***77-81 Berry Street & 88 Walker Street,
North Sydney***

***MP08_0238 MOD 5 – Modification to approved
Commercial and Hotel Development***

Secretary's
Environmental Assessment Report
Section 75W of the
Environmental Planning and Assessment Act 1979

Figure 3: Approved commercial and hotel towers (left) and proposed removal of hotel tower (right)

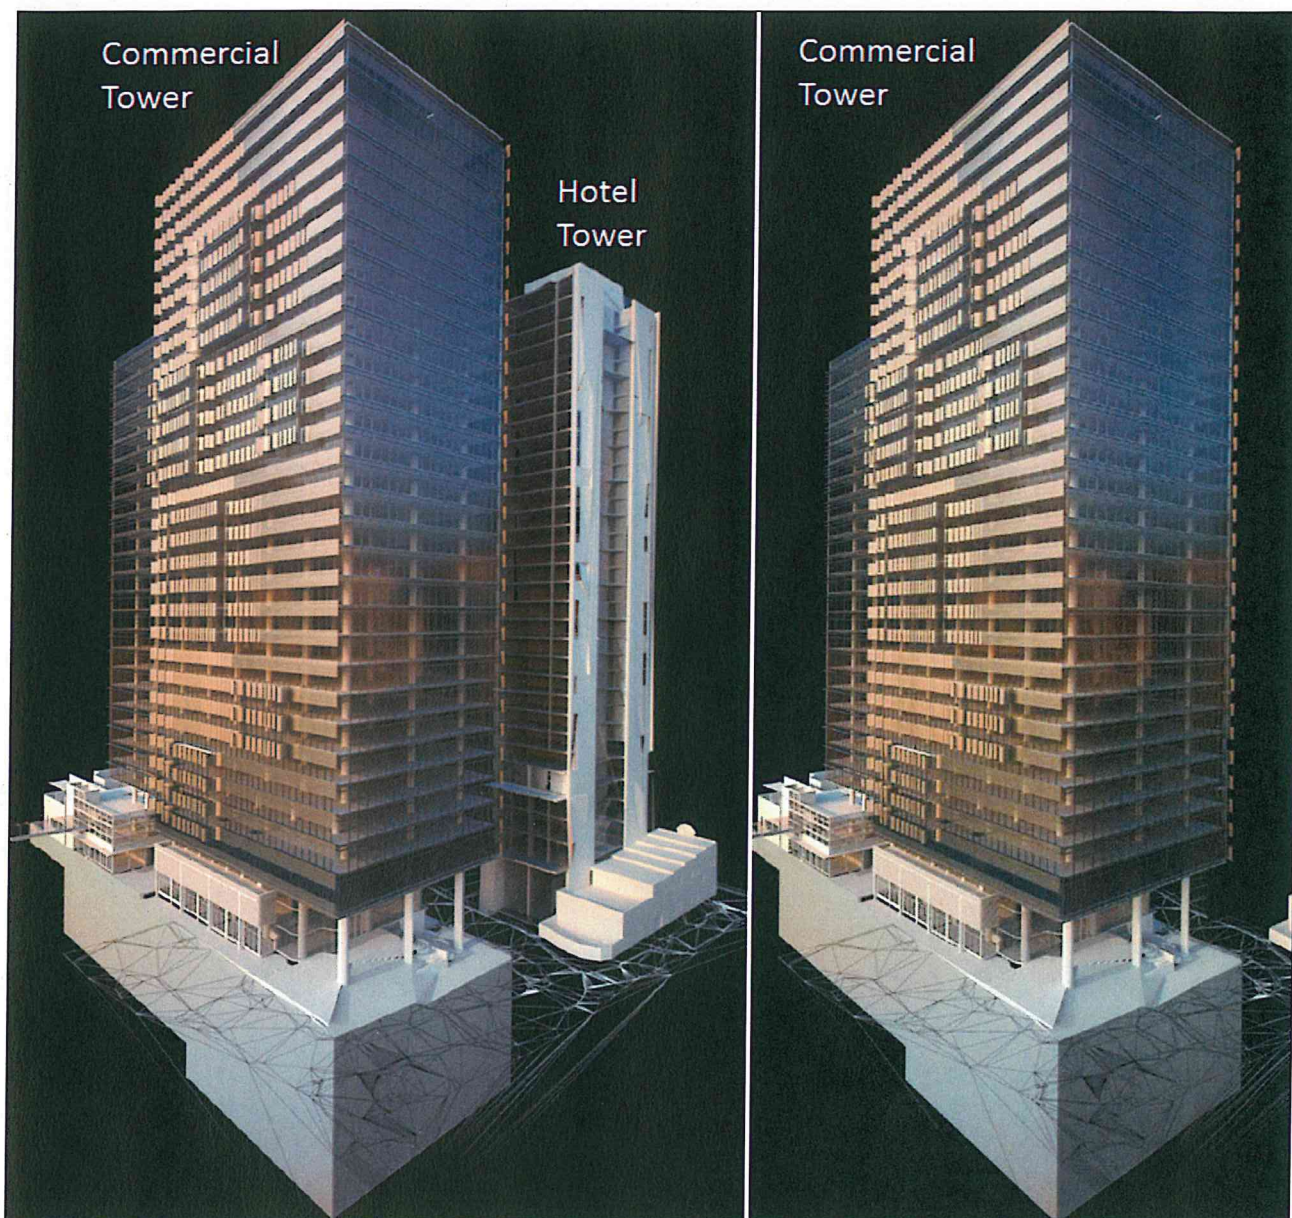
The proposal seeks to excise 88 Walker Street from the development site resulting in deletion of the approved hotel from the development. As the approved design of the commercial tower and hotel building were designed as two individual buildings on separate sites (**Figure 3**), the proposal will maintain the same built form for the commercial tower as approved. No external changes are proposed to the commercial tower and façade.

The Department is satisfied that 88 Walker Street is of a sufficient size and has appropriate access to enable it to be developed separately in accordance with the NSLEP 2013 controls. On this basis, the Department supports the deletion of 88 Walker Street and hotel component from the development.

Figure 4: Extracted of approved (above) and proposed (below) pedestrian bridge alignment over Denison Street

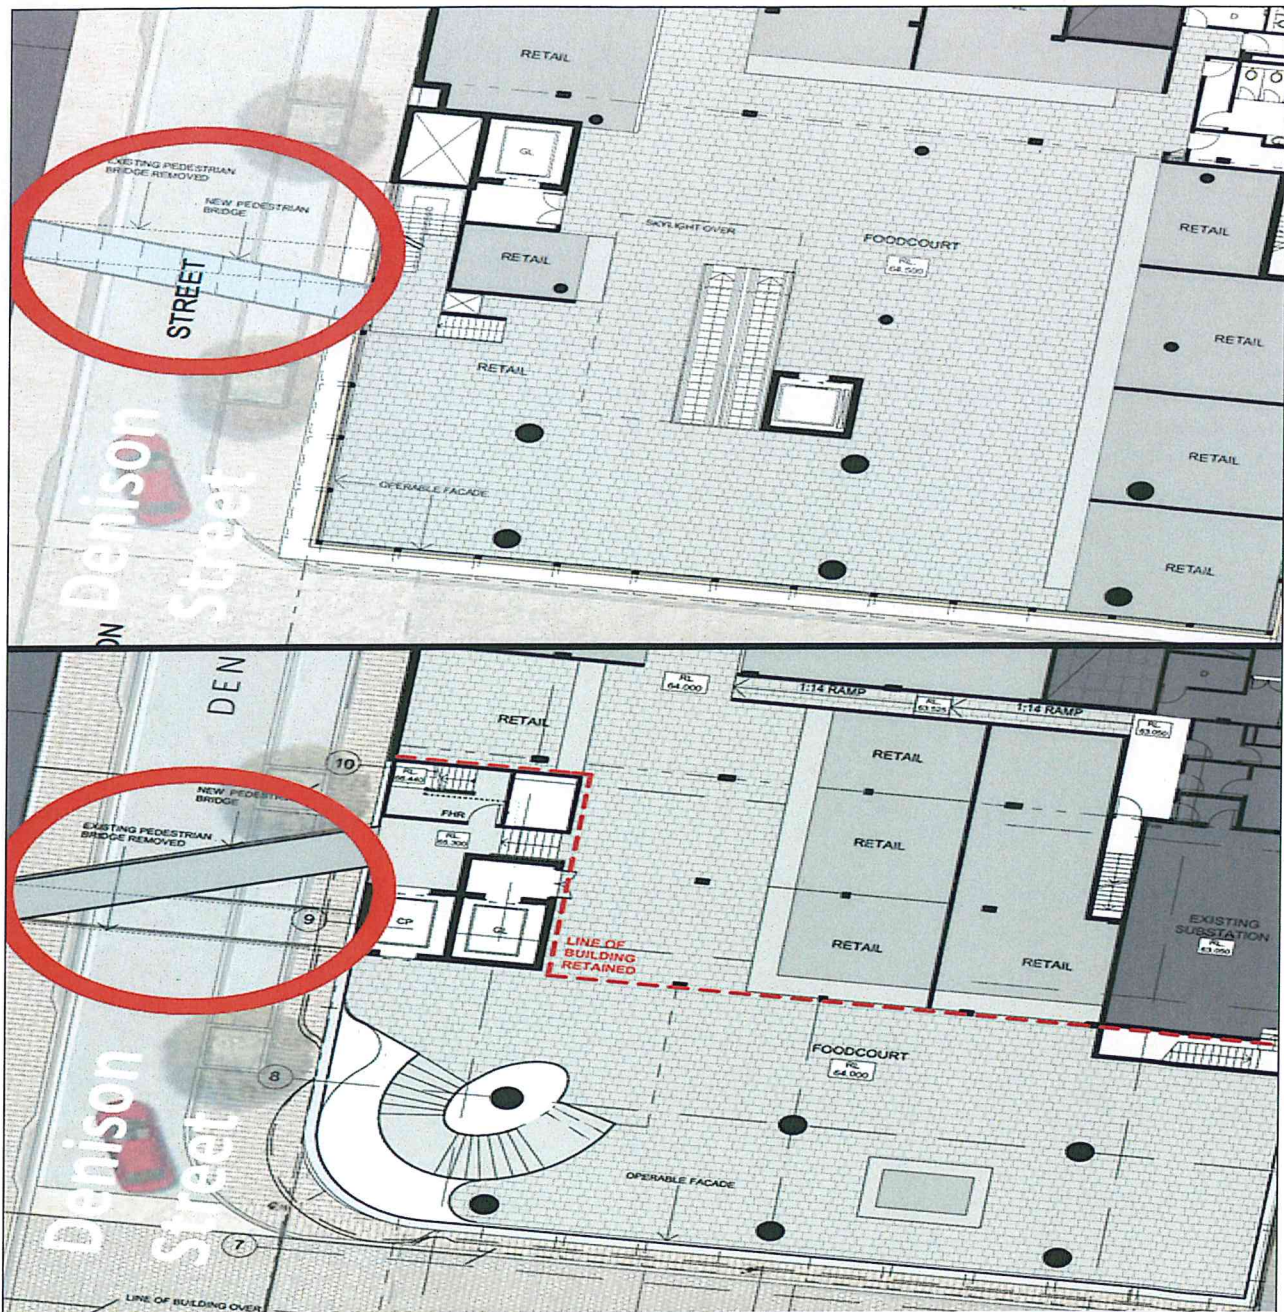
The approval also includes a new pedestrian bridge over Denison Street connecting 155-167 Miller Street with the commercial tower at Level 1. The pedestrian bridge is proposed to be realigned to accommodate the revised internal layout of the commercial tower. The realignment of the pedestrian bridge is minor and will continue to provide an appropriate connection between the two sites. The realignment will have negligible impacts on the streetscape of Denison Street (**Figure 4**).
